City of Ontario

ADDENDUM NO. 8 Bid Invitation # 1900

TODAY'S DATE:	Monday, April 14, 2025
PROJECT TITLE:	D&C23-022 Ontario Sports Empire
BID PACKAGE:	D&C23-022 Ontario Sports Empire (BC03 & BC18)
BID CLOSING DATE:	April 17, 2025 at 2 p.m. No Change
CITY RESPONSE:	April 10, 2025 No Change
Q & A DEADLINE:	March 27, 2025 at 5 p.m. No Change
PRE-BID WALK:	March 12, 2025 at 8 a.m.

Project: Ontario Sports Empire

SECTION 1
 SCALE: 1"=1'-0"

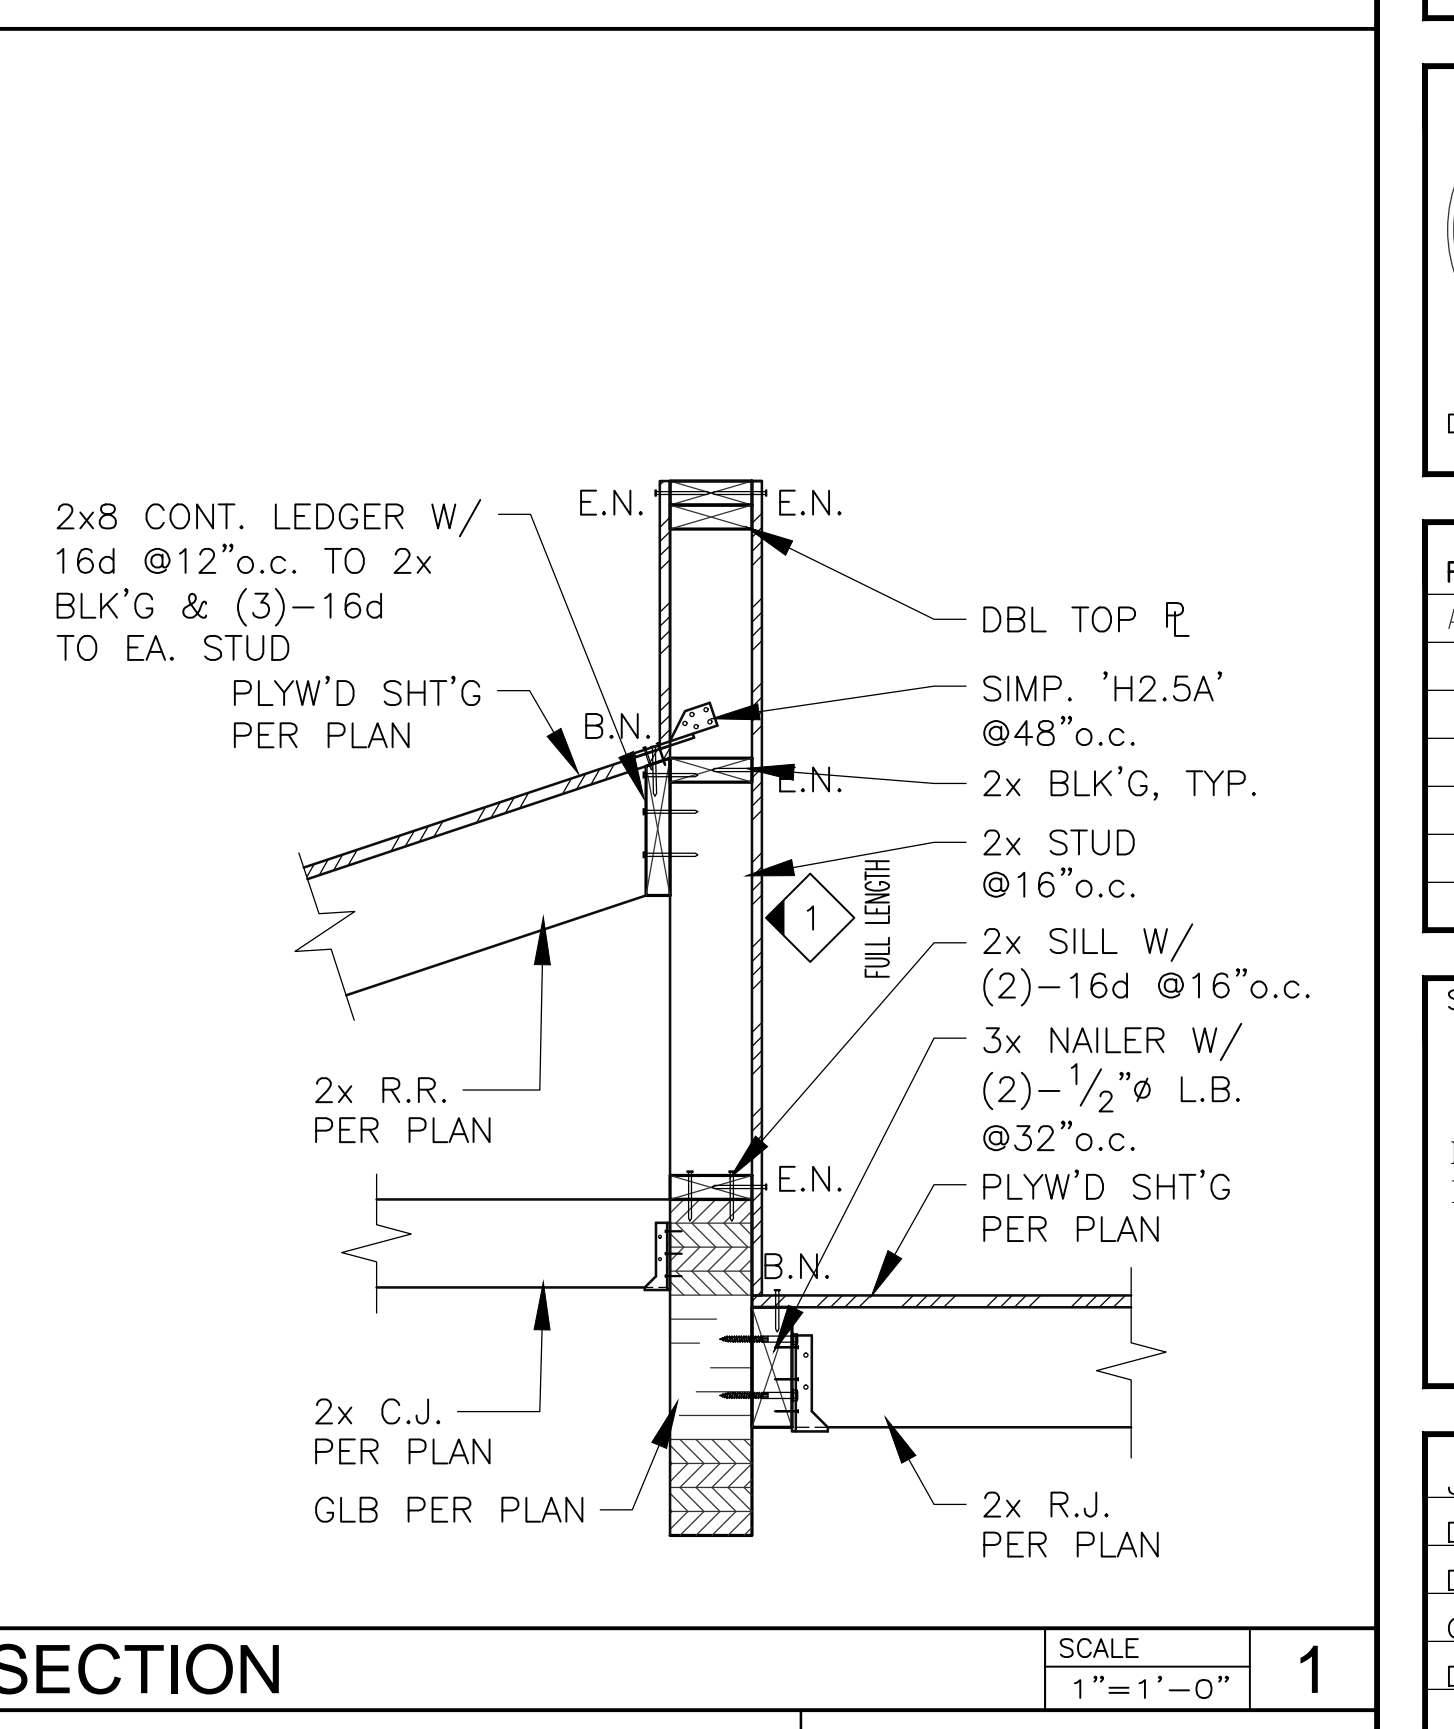
Green Room Building Mechanical Well, a) Where DBL joist are noted provide the size. b) Please note the locations for the roof & overflow drains. Would detail 12/S1.5 apply for the framing? Reference S8.1

A. USE DBL 2x6 CJ @16"o.c. NOTED PER PLAN.
B. ROOF & OVERFLOW DRAINS PER ARCHITECTURAL DRAWINGS ADDED ON S8.1. SIMILAR TO 12/S1.5. REFER TO ATTACHED DETAIL.
